ADDENDUM NO. TWO

PUBLIC WORKS VEHICLE MAINTENANCE FACILITY

CITY OF SOCIAL CIRCLE, GEORGIA

PROJECT NO. 242774

6 VEHICLE MAINTENANCE AND STORAGE LEFT ELEVATION
A4.01 SCALE: 3/32" = 1'-0"

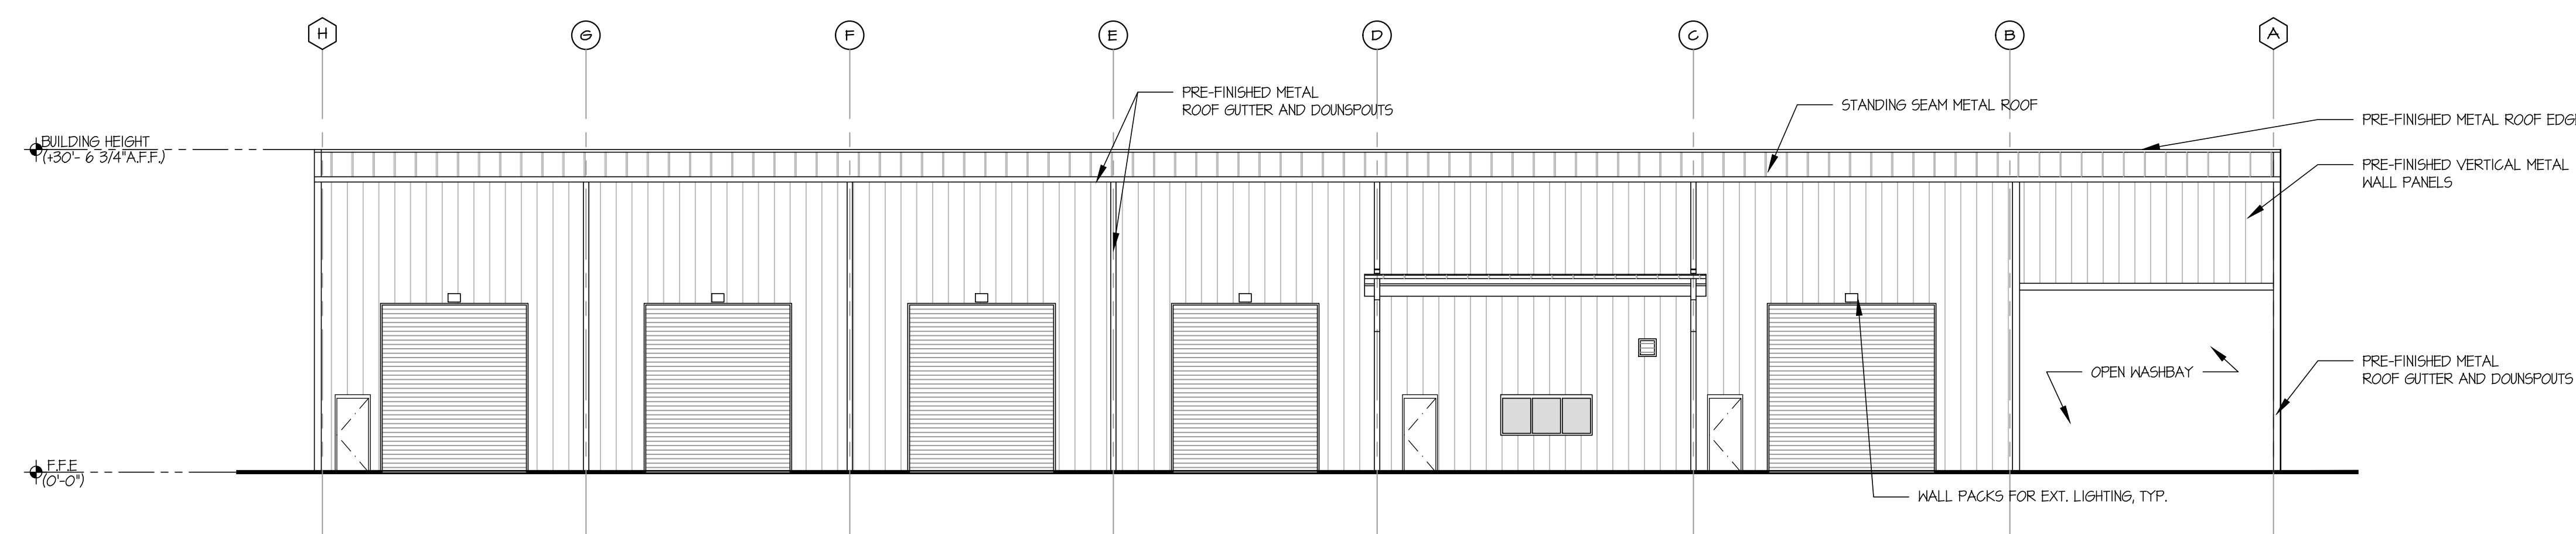
- 7. Elevation 6 on A4.01 is calling for a 4' high painted CMU wall. I don't see that shown on floor plan.**

Disregard reference to 4' high painted CMU wall.

SO.01

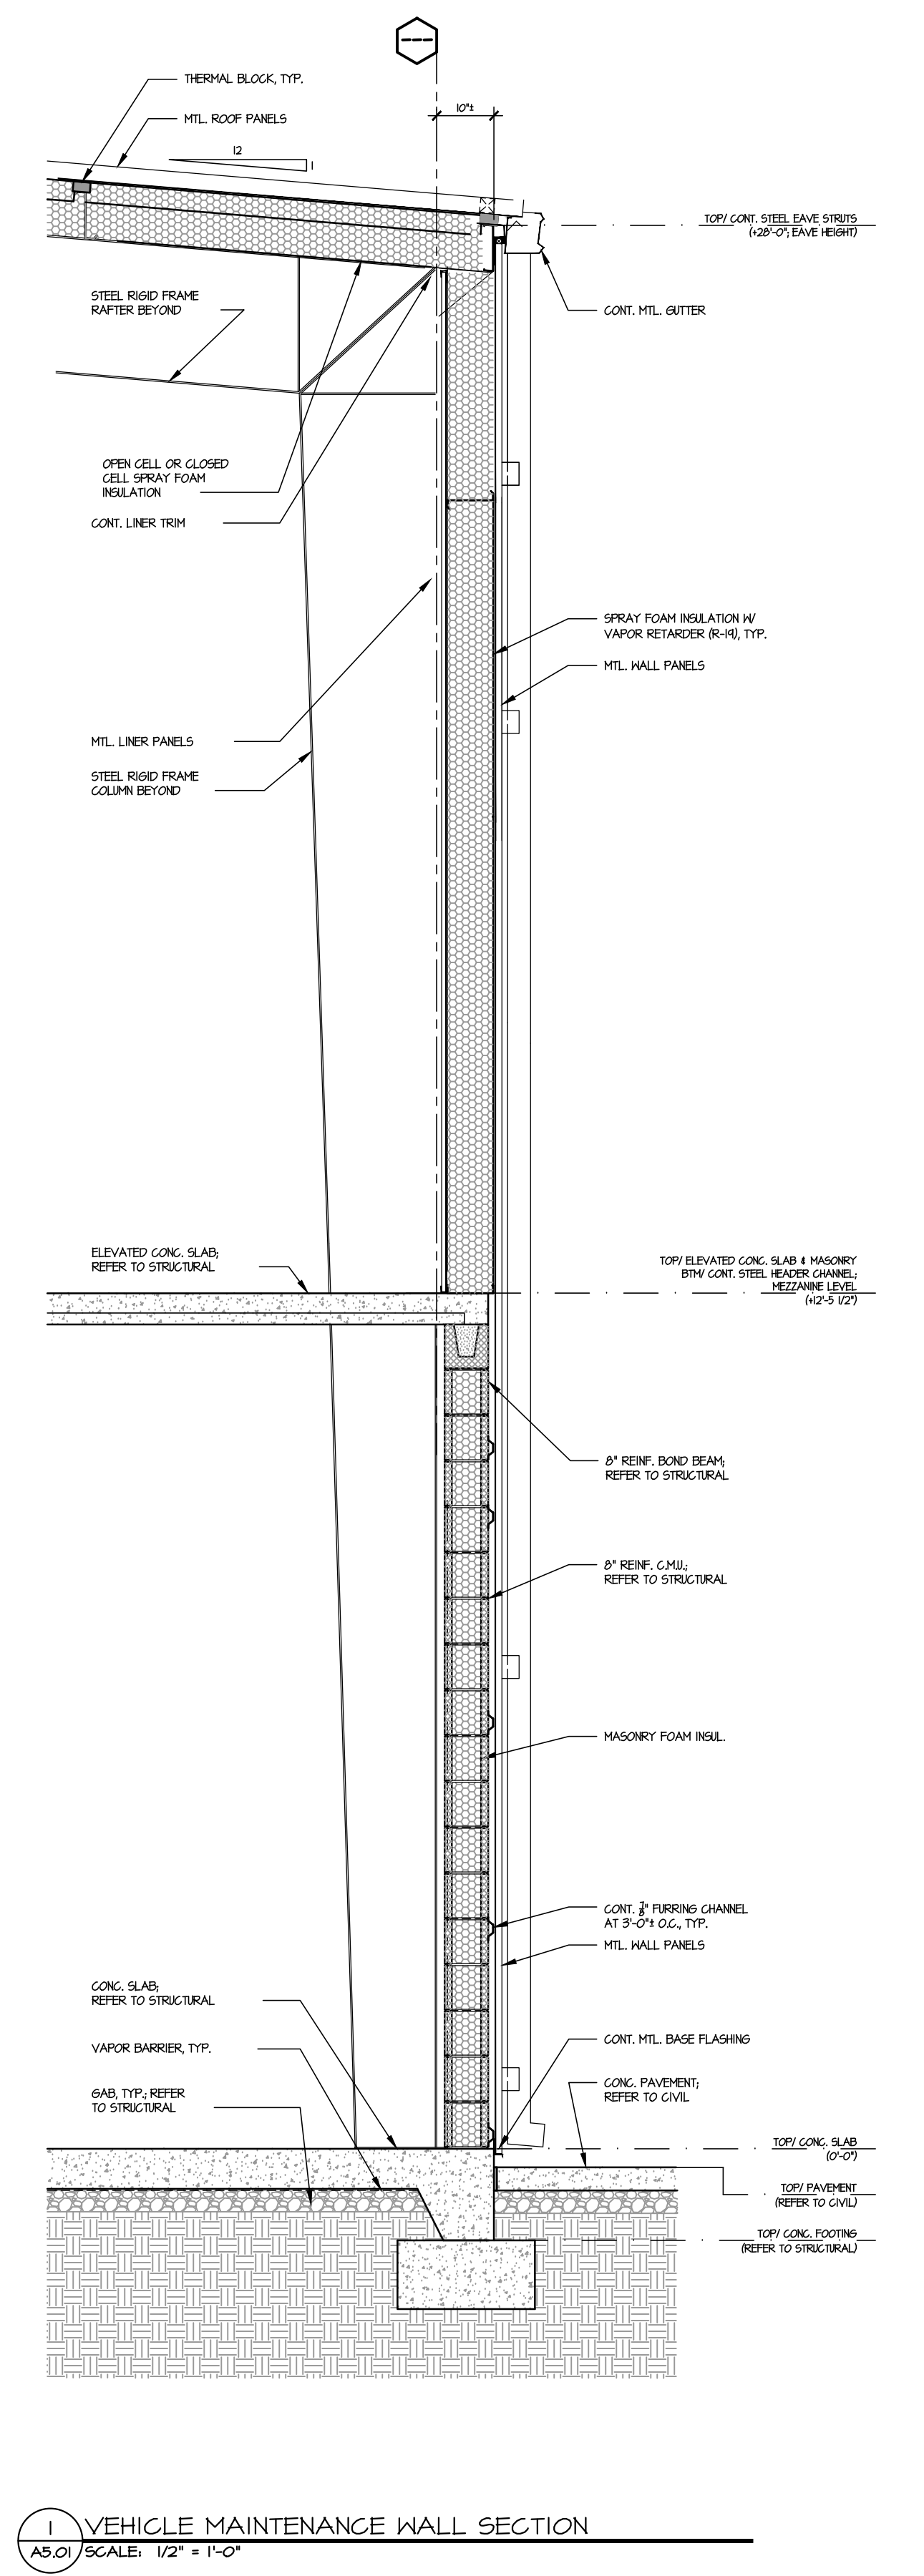
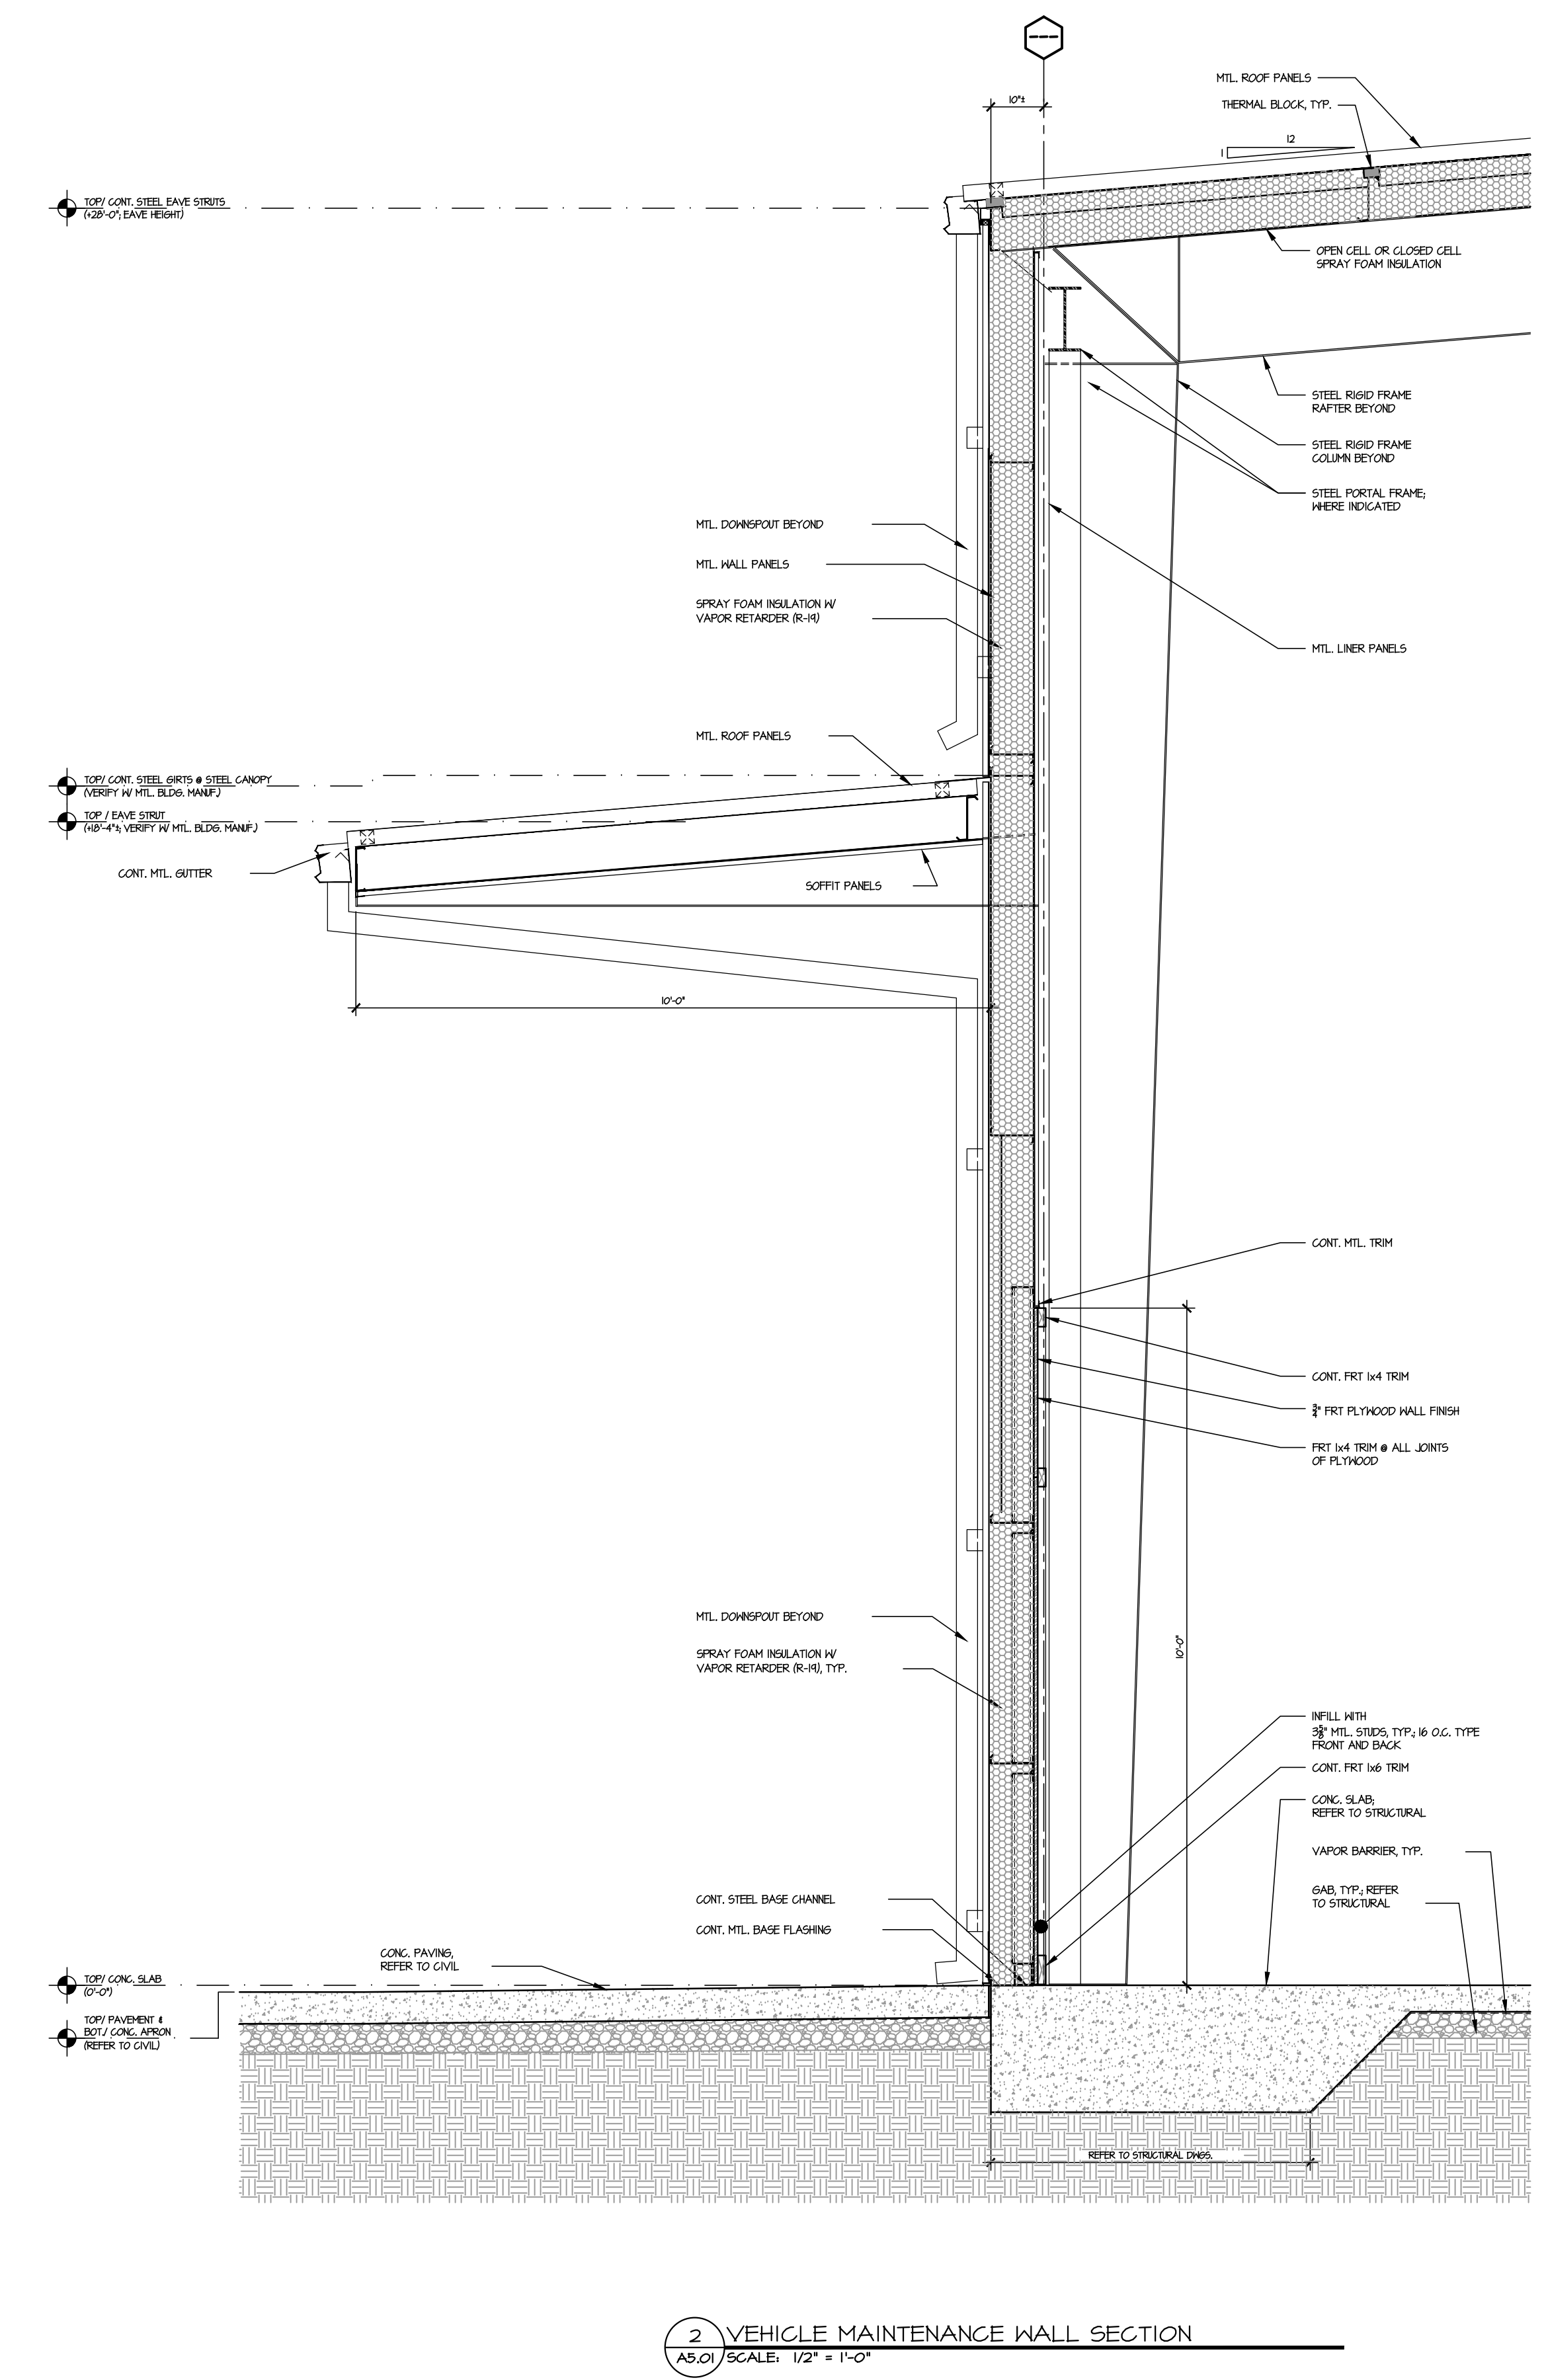
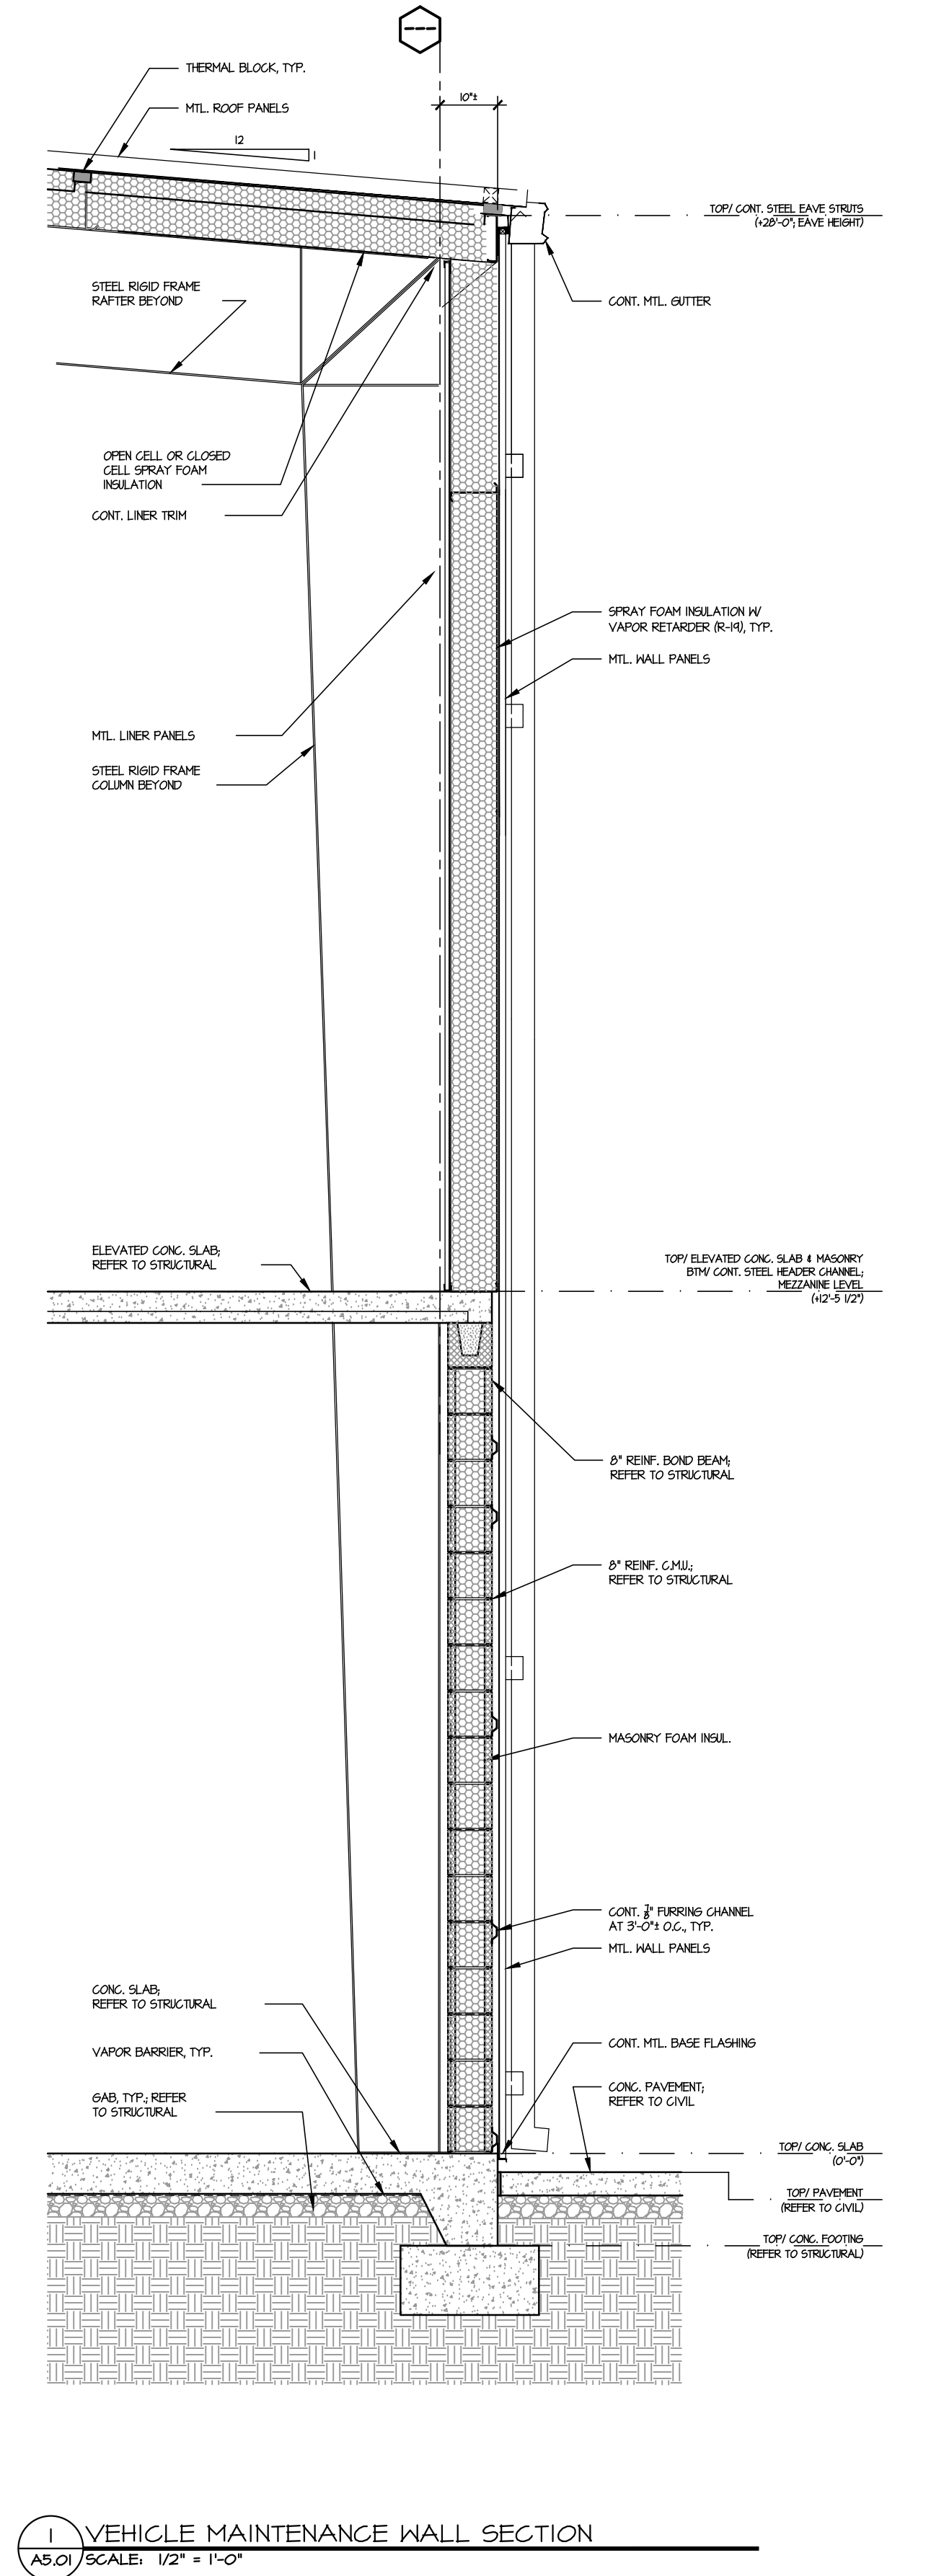
- 21. IBC 2024 was adopted statewide in GA as of Jan 2026, S0.01 reference IBC 2018. Please confirm this is grand fathered in on 2018.**

- 22. S0.01 – please confirm note 10 is accurate and requires structural jambs and headers for roll up and overhead doors. Sizes to be per PEMB design to fit within wall cavity.**

IBC 2024 is correct. Revised sheet S0.01 to be issued will indicate IBC 2024.

Note 10 is correct.
